ADDENDUM

Project Name:	UNK University Village Student Housing
Project Number:	15097
Owner:	University of Nebraska at Kearney
Addendum Number:	01, Revision 01
Date:	April 21, 2016
By:	Matt Neaderhiser, Holland Basham Architects
To:	Project Bidders

This Addendum to the project bidding documents and attached reference drawings dated April 21, 2016, issued to inform bidders of revisions to the bidding documents.

1 M1.00 Mech Site Plan - BASE

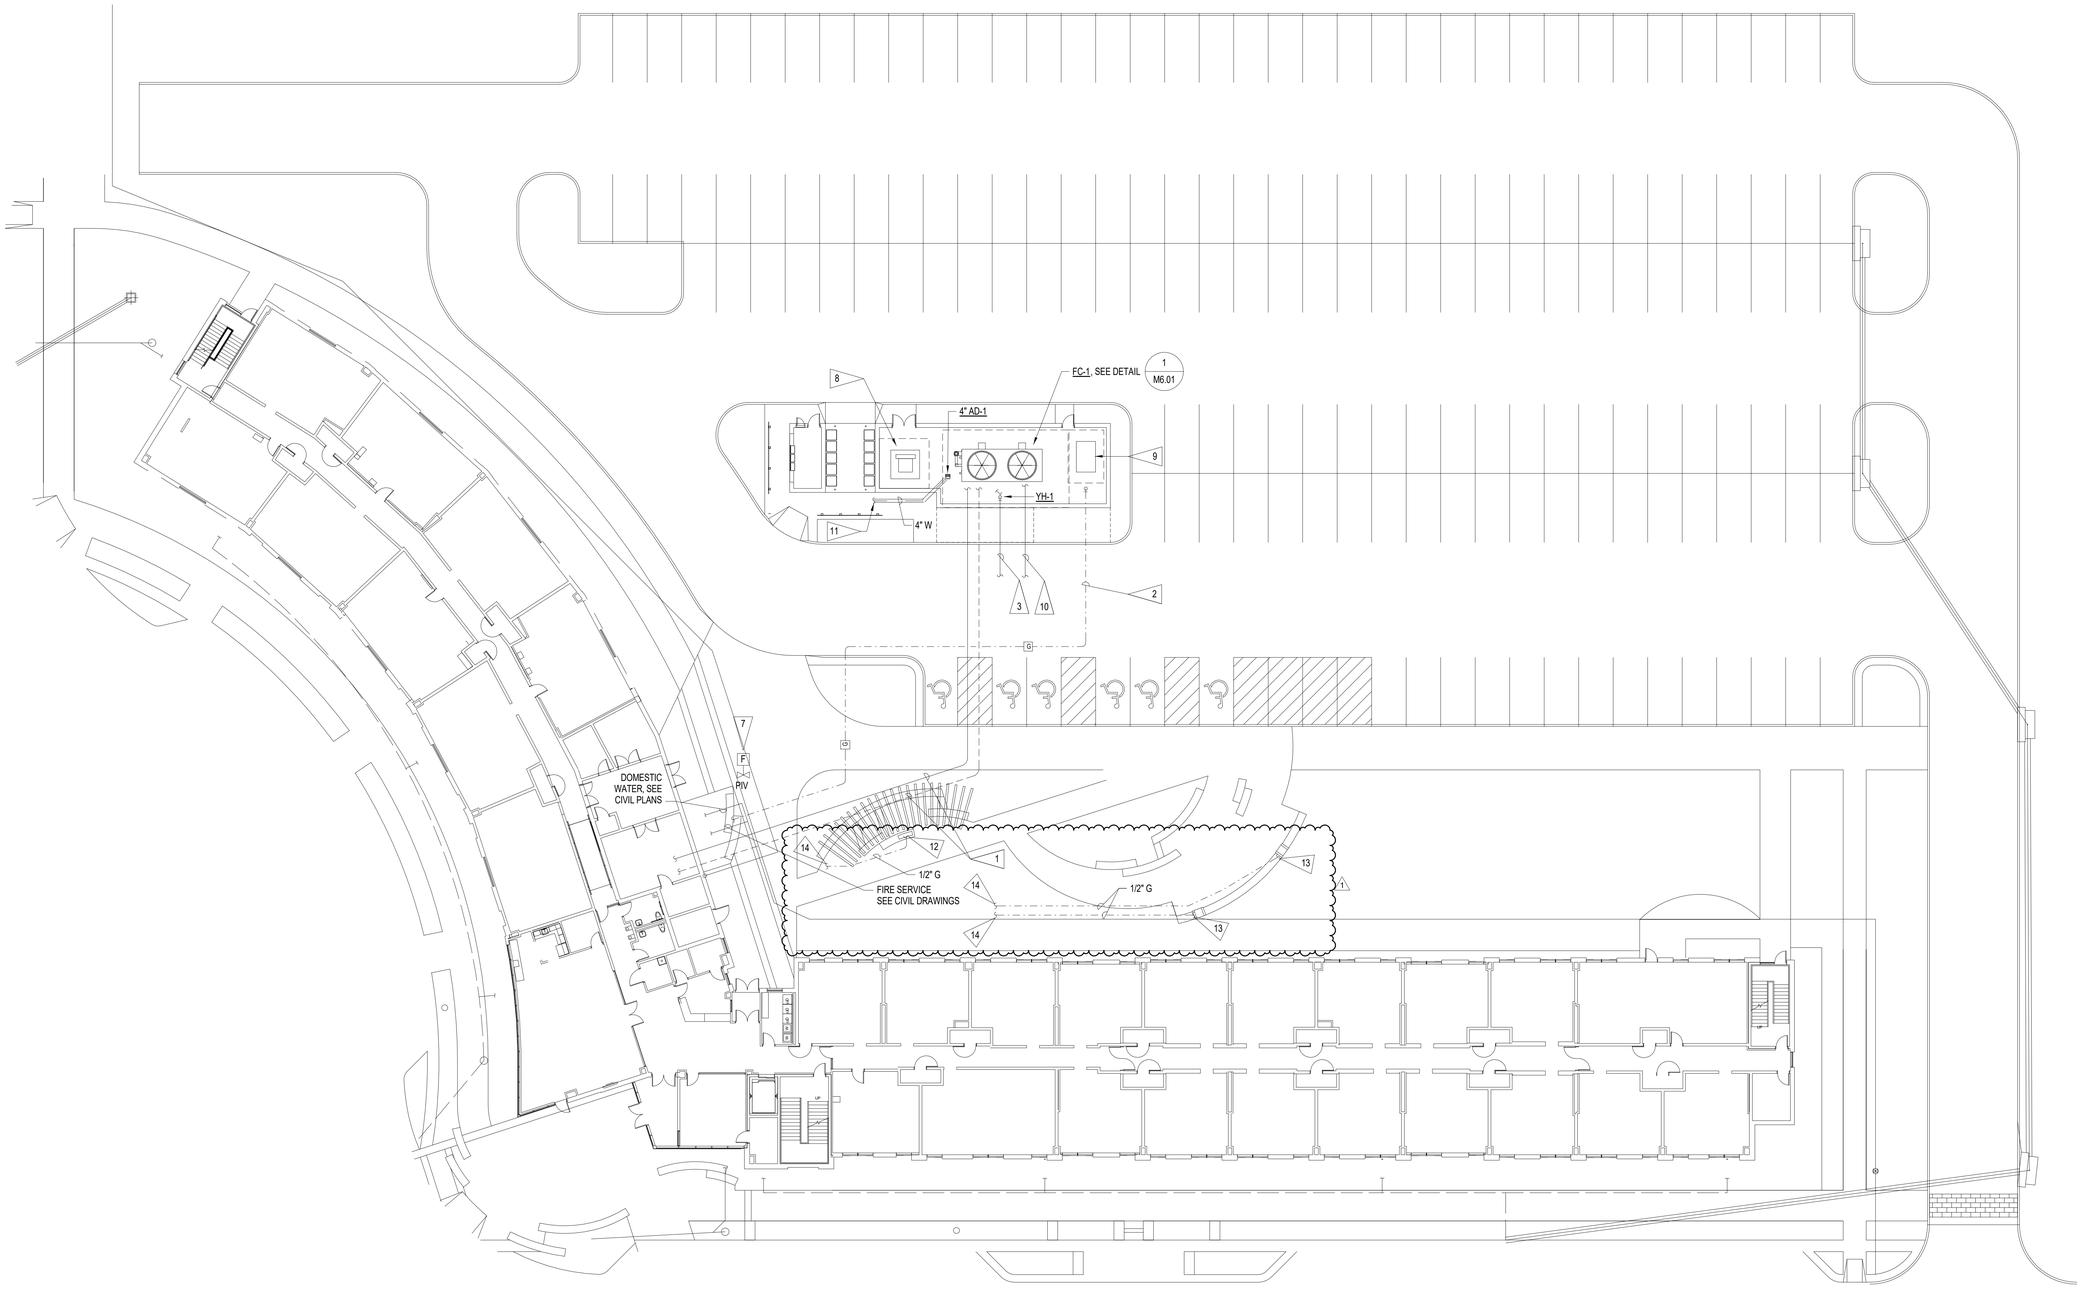
b. Base Bid HVAC – Water source heat pumps with fluid cooler and gas fired boilers.
i. Revised sheet M1.00 – Mechanical Site Plan
c. Alternate 2 – Geothermal water source heat pumps

1 M5.01 WASTE AND VENT RISERS
NOT TO SCALE

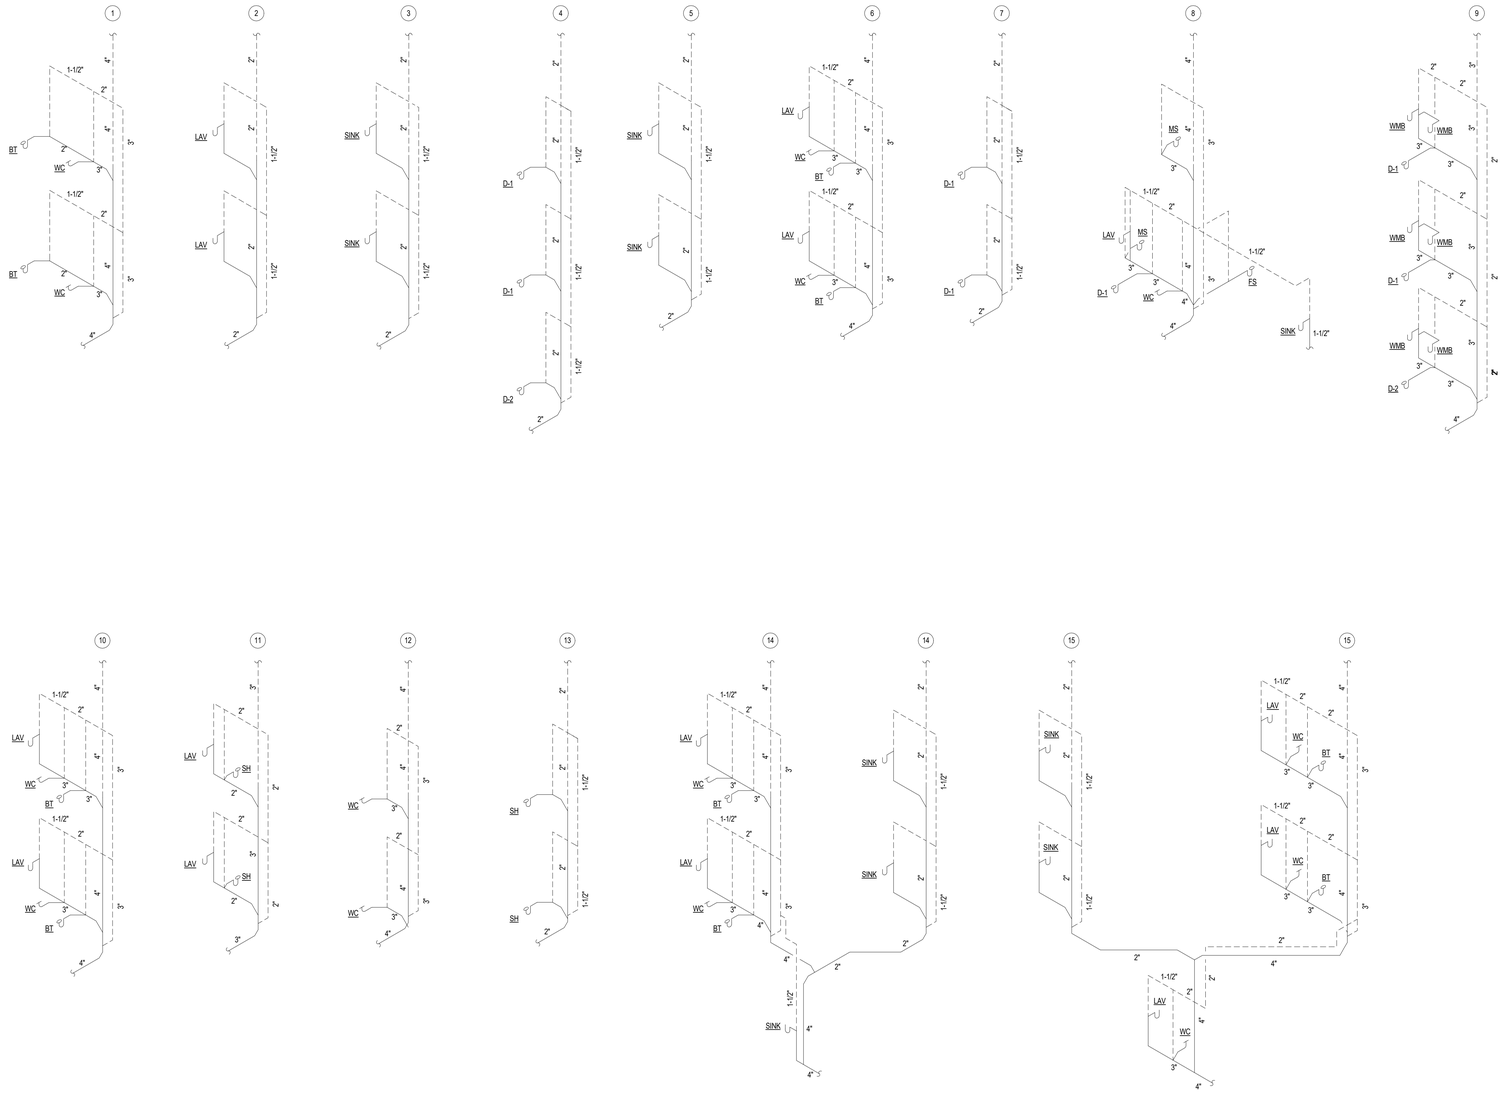
2. Revised underground and above ground waste and vent piping at the first floor to accommodate future conversion of first floor to Commercial Retail space.
a. In general, all risers offset at first floor to the nearest column. Plans have been revised as required. Individual changes are not clouded on plans. In general, all risers were affected.
b. See the following revised sheets: M3.00A, M3.00B, M3.01A, M3.01B, M3.02A, M3.02B, M3.03A, M3.03B, M5.01.

1 ES1.01 SITE PLAN

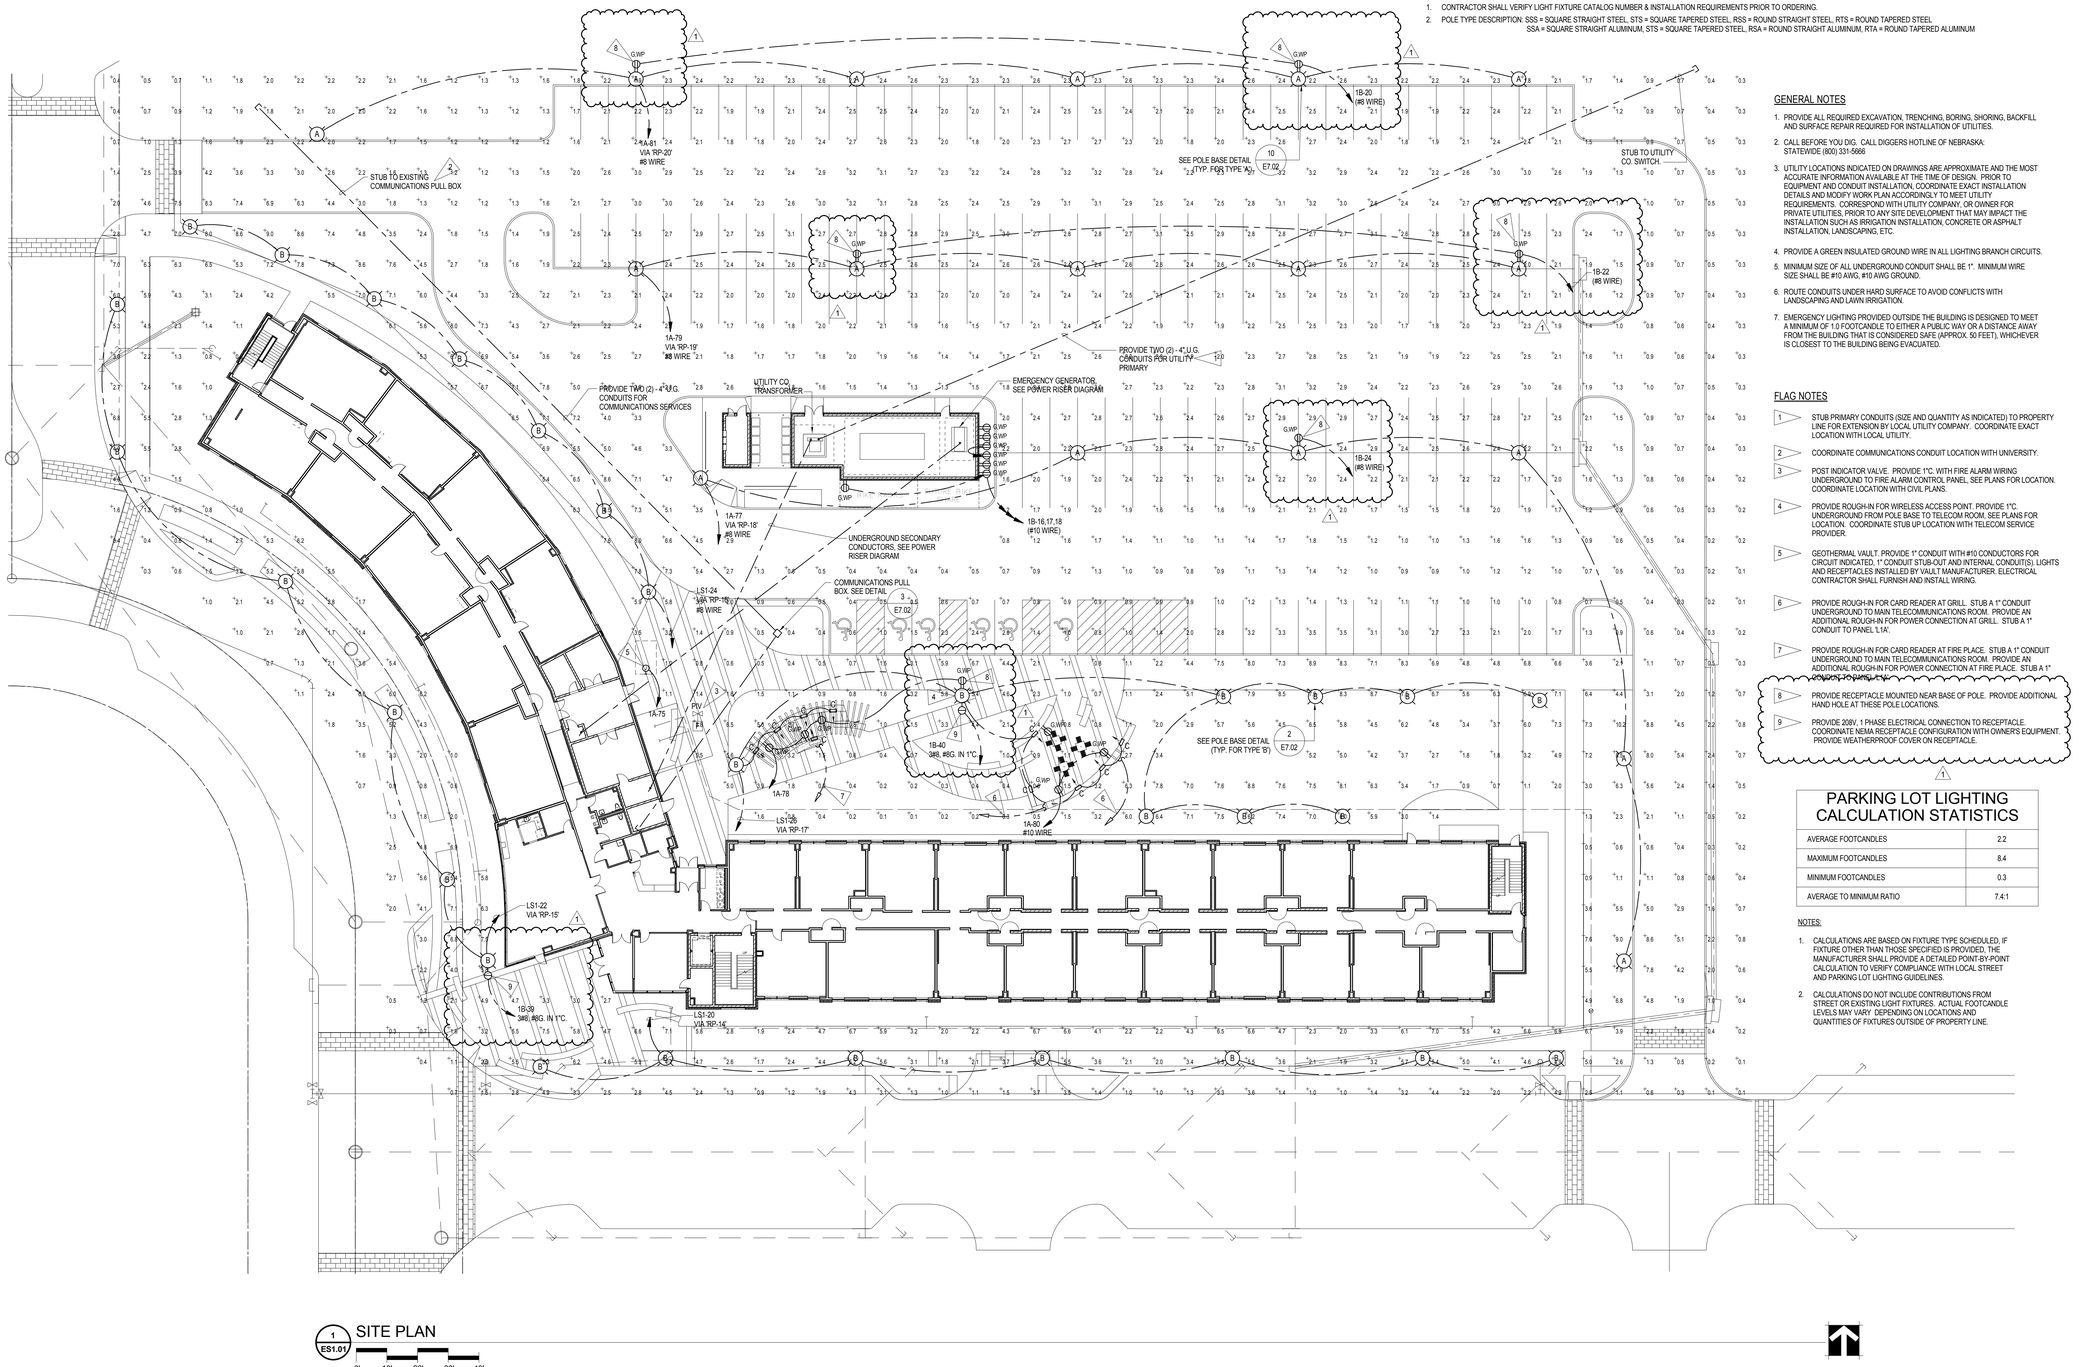
2. ES1.01 – Site Plan
    a. Add receptacles at pole lights.
    b. Add 208V receptacle at two pedestrian poles.

1 E1.01A FIRST FLOOR LIGHTING PLAN - WEST WING

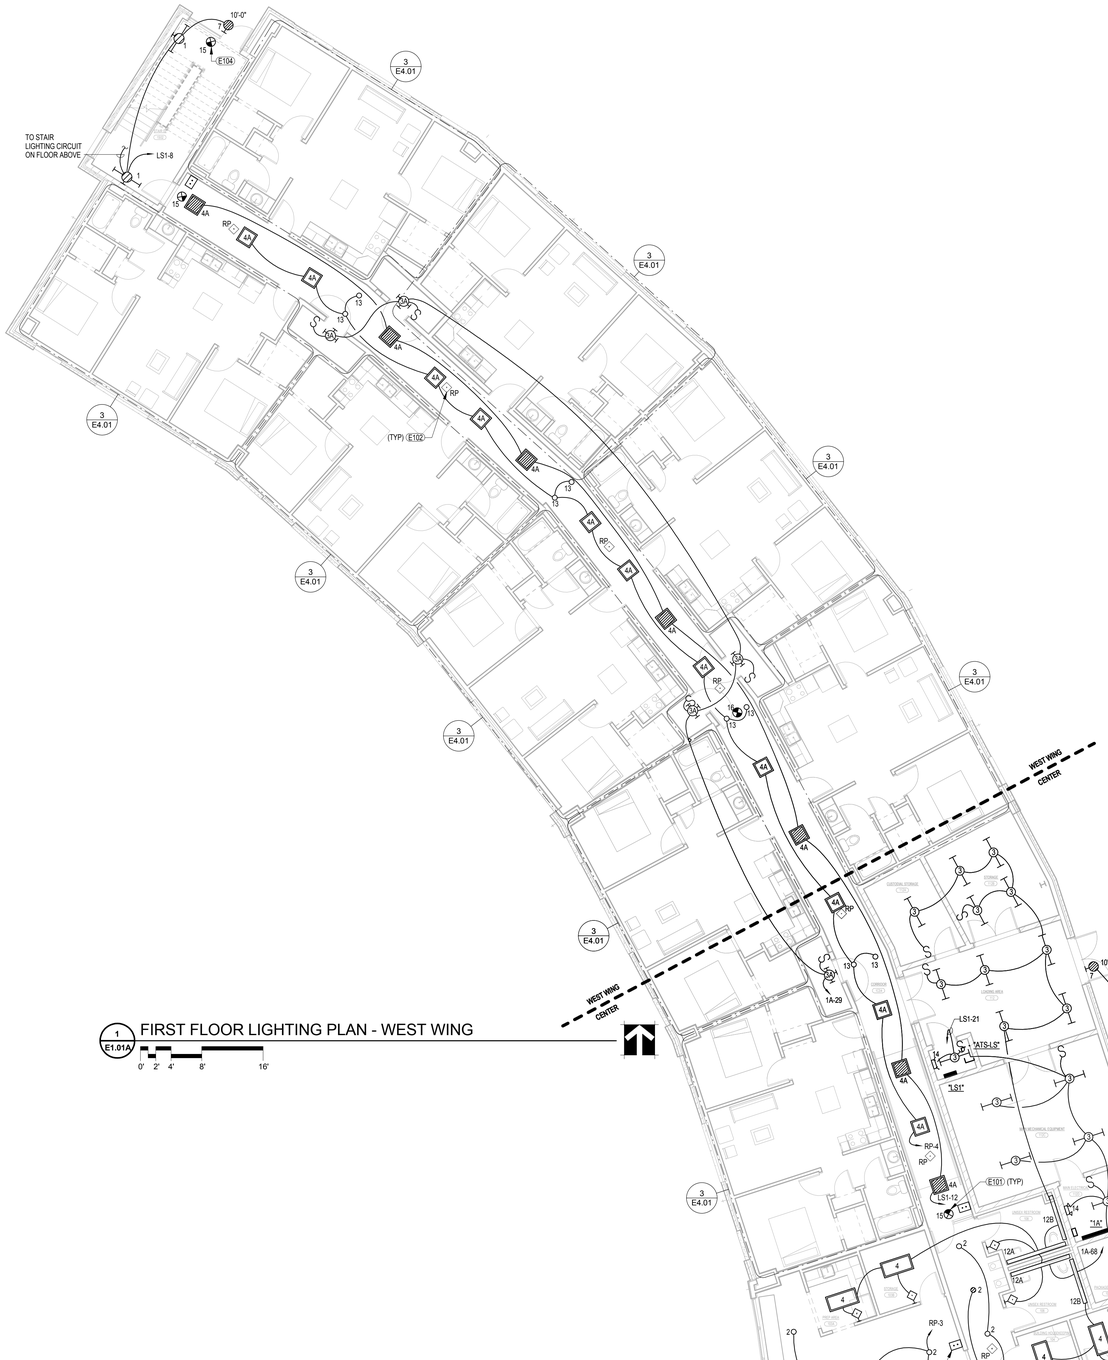
3. Sheet E1.01A – First Floor Lighting Plan – West Wing & Center
    a. Add automatic load control relays.

1 E1.02A SECOND FLOOR LIGHTING PLAN - WEST WING

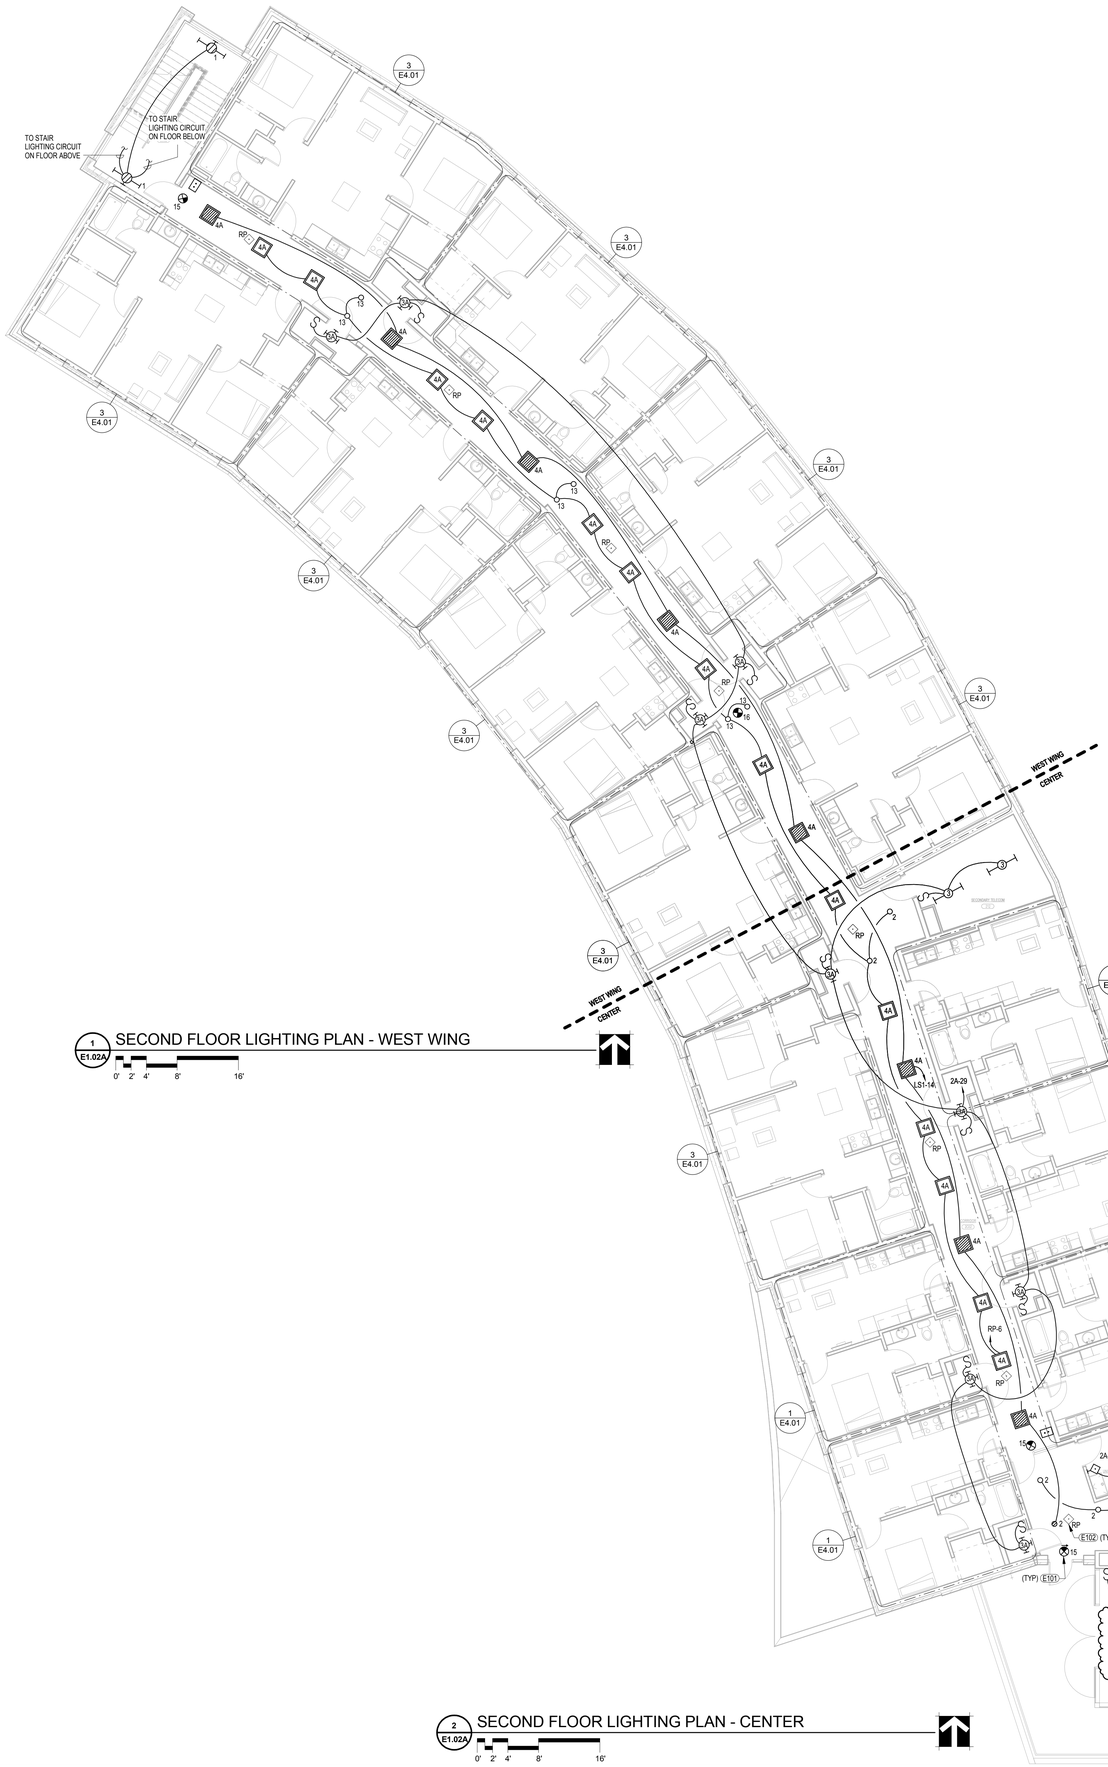
4. Sheet E1.02A – Second Floor Lighting Plan – West Wing & Center
    a. Add automatic load control relays.
